**ADDENDUM TO
STORMWATER MANAGEMENT REPORT**

**371 BOSTON STREET
TOPSFIELD, MASSACHUSETTS**

**October 23, 2019
Revised: July 29, 2021**

Routing Diagram for 2669 Proposed Conditions
 Prepared by The Morin-Cameron Group, Inc.
 HydroCAD® 10.10-3a s/n 00401 © 2020 HydroCAD Software Solutions LLC

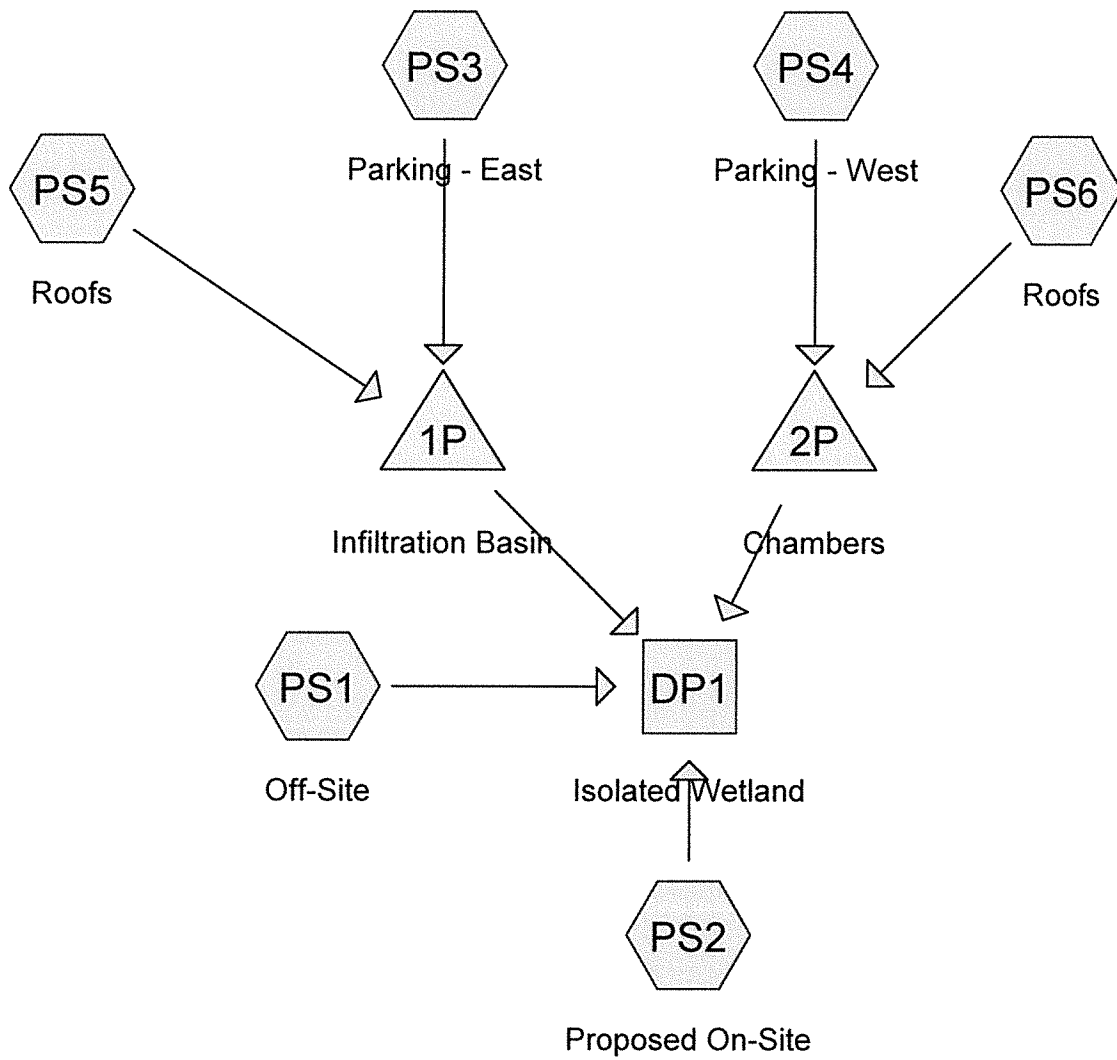
The stormwater management design was reviewed by the Topsfield Stormwater Officer, Dave Bond, for compliance with local and state stormwater management standards. Mr. Bond requested that the design be re-evaluated to see if the post condition 25-year storm could be mitigated to maintain or reduce the existing conditions 25-year storm peak stormwater runoff rates. The design was re-evaluated and it was determined that modifications to the outlet control structure of the underground chamber system and modifications to the emergency spillway elevation and outlet control structure for the infiltration basin would reduce the post development 25-year storm peak runoff rate to match the existing conditions 25-year storm peak runoff rate.

As shown in the tables above the proposed development will maintain or reduce peak flow rates and volumes to DP 1 for the 2, 10 and 25-year design storm events. In conclusion, the modified drainage system is in full compliance with the Town's Stormwater and Erosion Control Regulations and the MA DEP Stormwater Management Standards. The proposed development will have no adverse impacts on abutting properties or wetland resource areas.
